Estates at Cathedral Pines  
Trip Generation & Access Technical Memo  
(LSC #S224150)  
EPC PCD File No. PUDSP2210 & SF2234  
January 8, 2024

**LSC Responses to  
TIS redline comments**

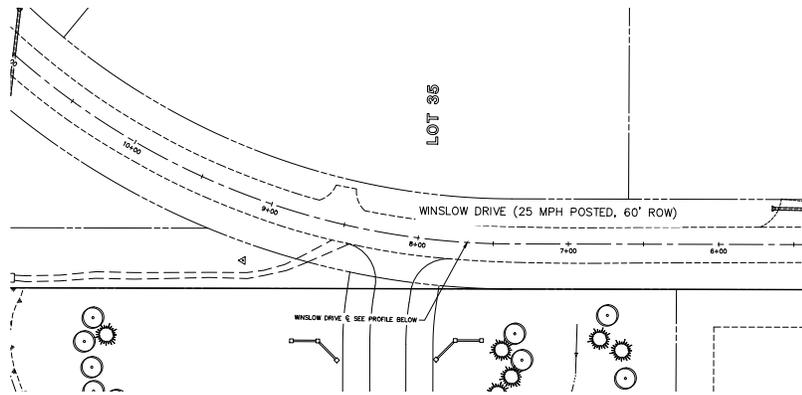
Provide exhibit of intersection sight distance and state what the sight distance specifically is. The stopping sight distance exhibits do not depict the intersection sight distance.

LSC Response: Intersection/entering sight distance has been added to the TIS.

**WINSLOW DR PROFILE**  
STA 5+50.00 TO 10+50.00

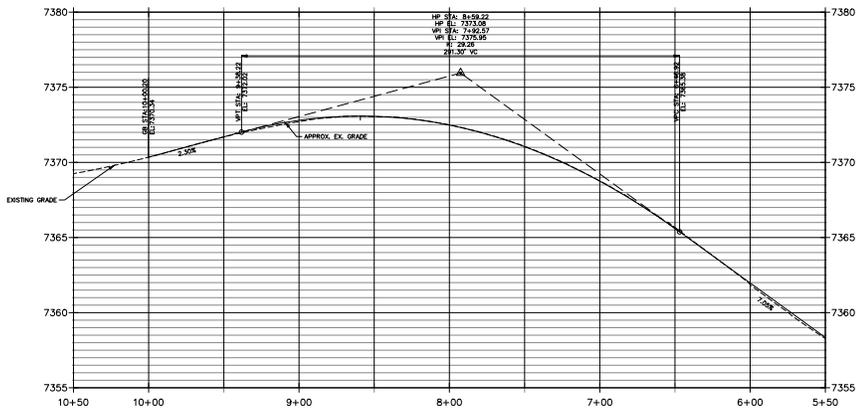
**1** See exhibit that shows intersection sight distance Per Table 2-2.23 and Figure 2-23

Provide exhibit that shows intersection sight distance Per Table Table 2-21 and Figure 2-33
